MFN 08-210

Docket No. 52-010

Subject: **Response to Portion of NRC Request for Additional
Information Letter No. 124 Related to ESBWR Design
Certification Application – Turbine Main Steam System –
RAI Number 10.2-27**

**Response to Portion of NRC Request for
Additional Information Letter No. 124
Related to ESBWR Design Certification Application
Turbine Main Steam System
RAI Number 10.2-27**

Figure 3.2-1. Quality Group and Seismic Category Classification Applicable to Power Conversion System

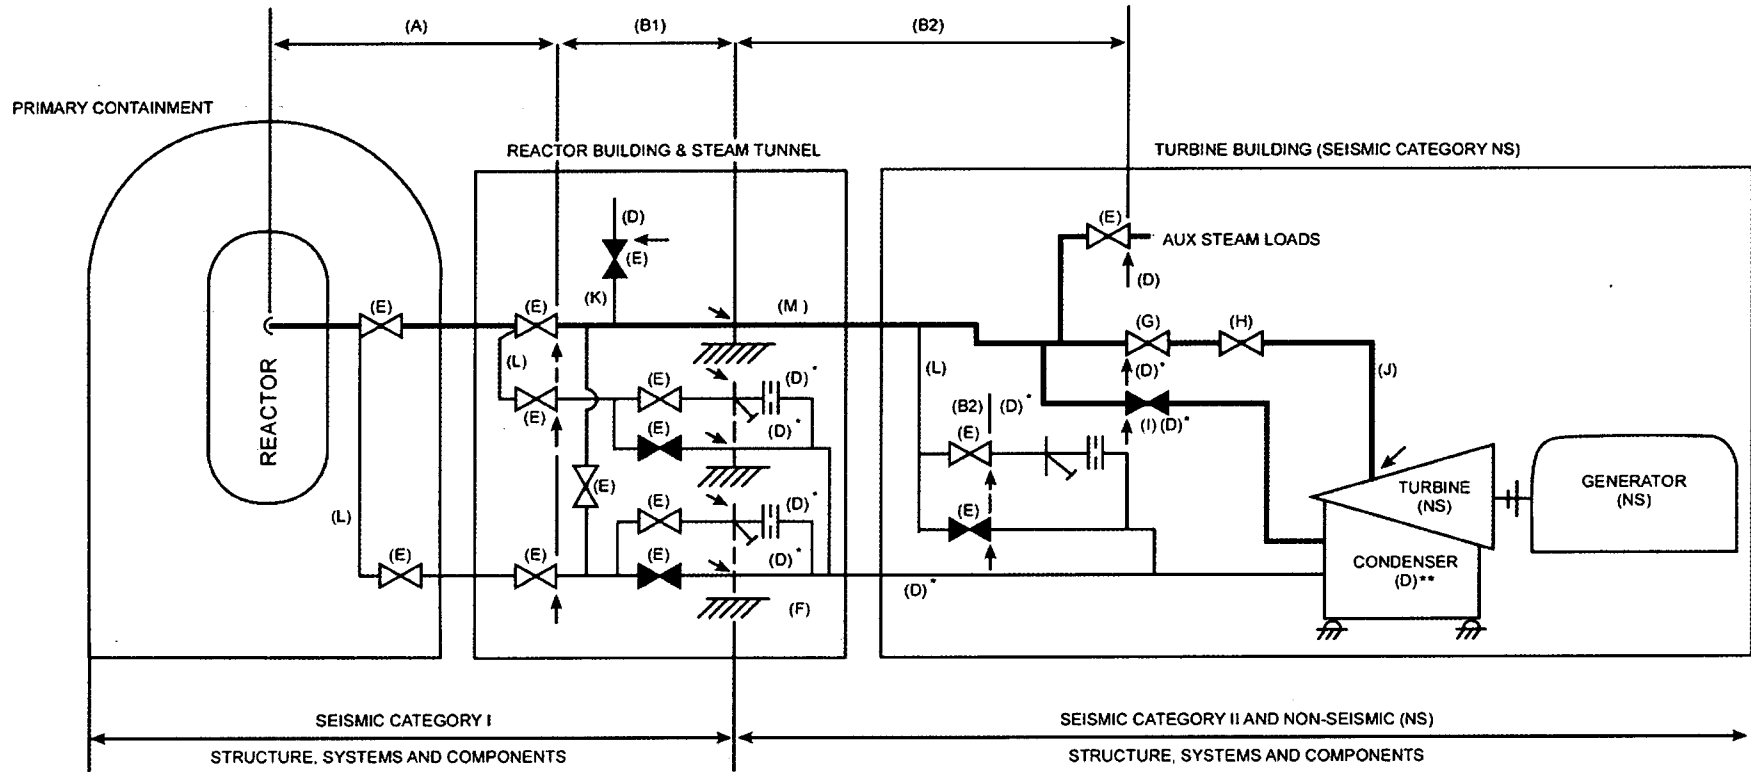
DCD Tier 2, Section 10.2.1.1, Revision 3, states that the main steam stop valve and steam line from the stop valve to the turbine are analyzed to maintain structural integrity following a safe shutdown earthquake (SSE). This statement was deleted in Revision 4. However, this is inconsistent with footnote (9) in Table 3.2-1. Please clarify the seismic design of the turbine stop valves.

DCD Tier 2, Figure 3.2-1 will be revised in Revision 5 as noted on the attached markup page.

DCD Tier 2, Revision 4, Subsection 10.2.2.1, states "TG system components, equipment, and piping are classified as discussed in Section 3.2." Further clarification of the seismic design requirements will be included in DCD Revision 5. This will include clarification of footnote 9 on Table 3.2-1.

LEGEND:				
A.	QUALITY GROUP A	I.	TURBINE BYPASS VALVE	* ANALYZED TO DEMONSTRATE STRUCTURAL INTEGRITY UNDER SSE LOADING CONDITIONS FOR MSIV LEAKAGE PATH
B 1.	QUALITY GROUP B		J.	
B 2.	QUALITY GROUP B, SEISMIC CATEGORY II	K.	INSTRUMENT BRANCH LINE	** CONDENSER SUPPORTS AND ANCHORS ARE DESIGNED TO MAINTAIN CONDENSER INTEGRITY FOLLOWING SSE FOR MSIV LEAKAGE HOLDUP VOLUME.
D.	QUALITY GROUP D	L.	DRAIN LINE	
E.	ISOLATION VALVE	M.	STEAM LINE	
F.	SEISMIC INTERFACE RESTRAINT	NS	NON-SEISMIC	
G.	TURBINE STOP VALVE	↙	CLASSIFICATION CHANGE	
H.	TURBINE CONTROL VALVE
